Product Change Notification

Change Notification #: 114287 - 00
Change Title: The Intel® Ethernet Server Adapter series: I350-DA4, I350-F2, I350-T2V2, I350-T4V2, OEM Generic, Product Codes: I350DA4G1P20, MM# 915704, I350F2G1P20, MM# 914215, I350T2G2P20, MM# 934607, I350T4G2P20, MM# 934608
PCN 114287-00, Transport Media, Label Shipping Carton Update, Regulatory Mark and Label Update
Date of Publication: January 4, 2016

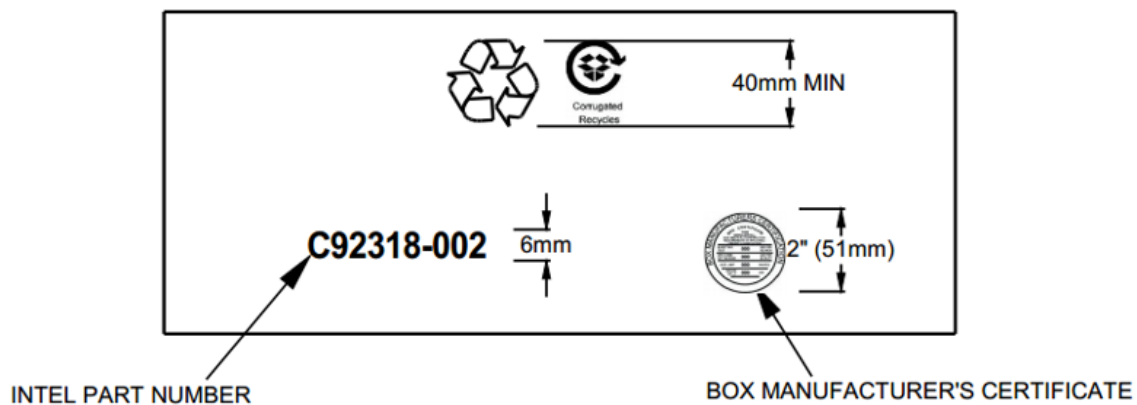
1. To reduce the occurrence of damages during shipping, Intel is increasing the strength of the outer box carton. The part number on the carton will change from C92318-001 to C92318-002, as shown below:

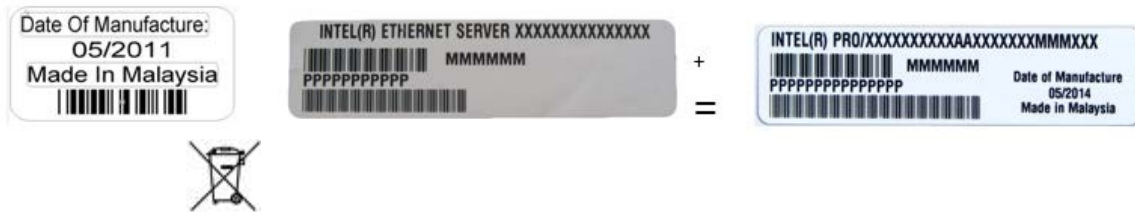
Combining of KCC and/or Date of Manufacture label with the product ID label to minimize labels on the board. In addition we'll be taking the opportunity to:

| • Remove | Reg label | KCC_DOM |
| • Edit | PID label | Product ID |
| • To Include | PID label | Product ID + DOM |
